UNITED STATES PATENT AND TRADEMARK OFFICE

APPLICATION NO.	FILING DATE	FIRST NAMED INVENTOR	ATTORNEY DOCKET NO.	CONFIRMATION NO.
10/708,521	03/09/2004	Joseph E. Broyles	R254	2520
22692	7590	04/03/2007		
REGINALD F ROBERTS JR 1422 HEARTHSTONE DRIVE BATON ROUGE, LA 70808-1161			EXAMINER SAN MIGUEL, ANITZA M	
			ART UNIT	PAPER NUMBER
			3733

Office Action Summary

DETAILED ACTION***Drawings***

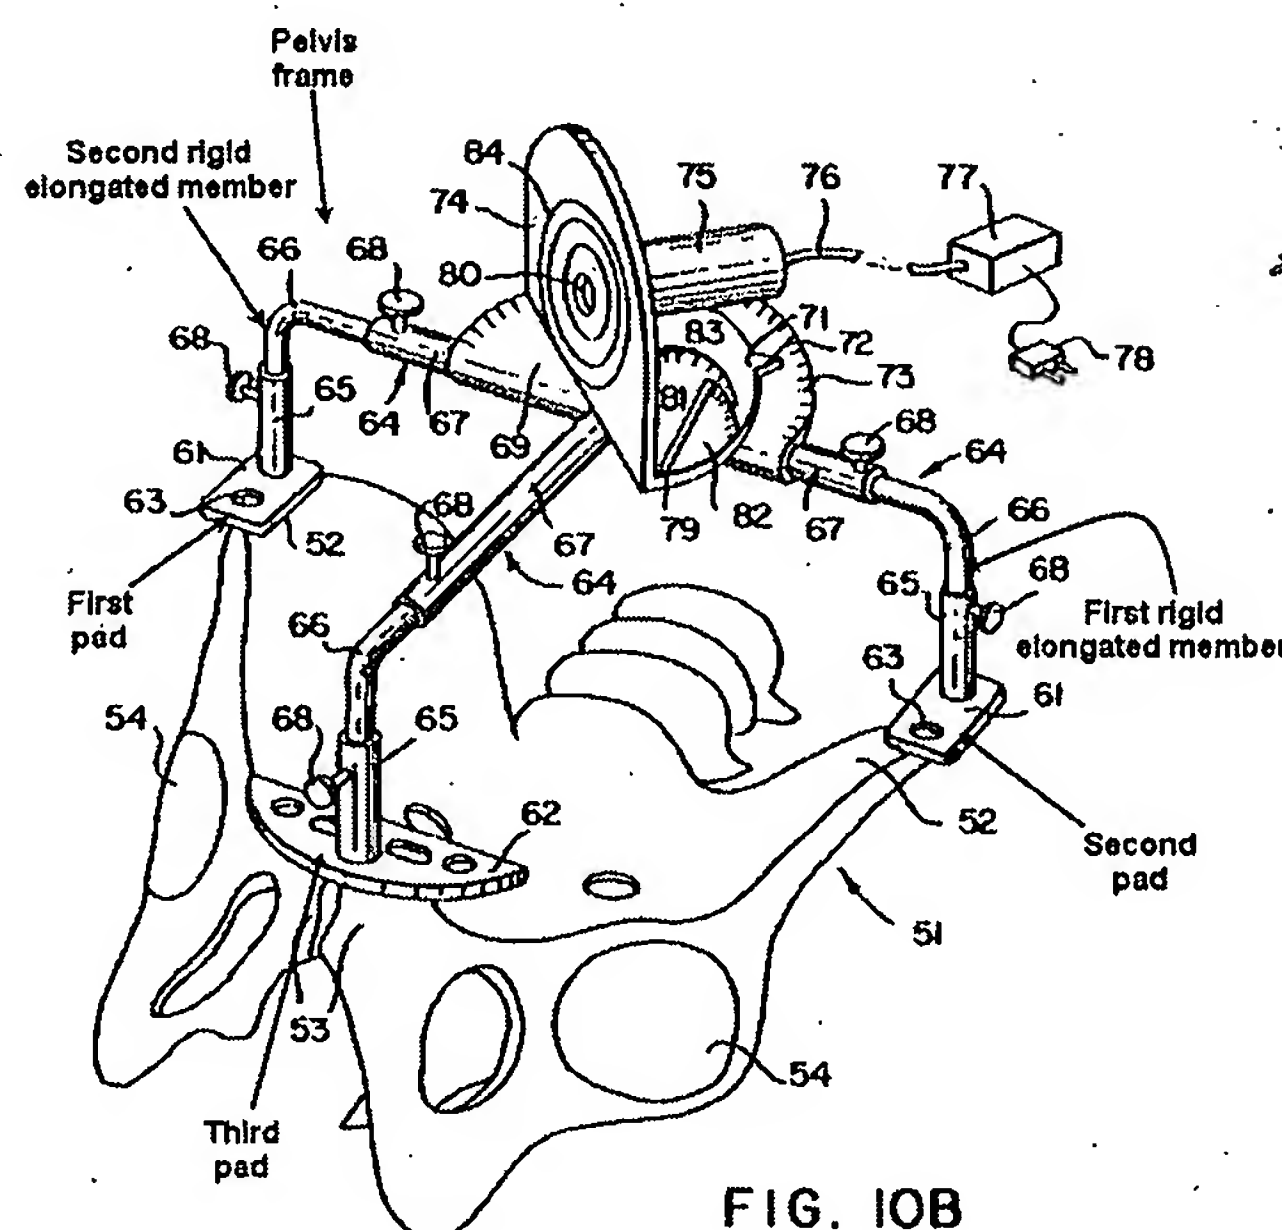
Farmer et al. discloses a pelvis frame comprising: a first rigid elongated member (see Figure 10B below); a second rigid elongated member mounted on the first rigid

elongated member in a perpendicular relationship thereto (see Figure 10B below); first and second pads attached to the first rigid elongated member in a perpendicular configuration (see Figure 10B below); a third pad attached to the second elongated member in a perpendicular configuration (see Figure 10B below); and means for varying position of the first, second, and third pads, and for fixating said position as required, for effecting orientation-determining contact of the first, second, and third pads with pelvic bone of the patient; the first, second, and third pads being contoured to conform to portions of the pelvic bone which said pads contact (col. 2, lines 4-16; col. 9, lines 14-31). The first and second pads include openings (63) for insertion therethrough of first and second wires used to determine the patient's orientation.
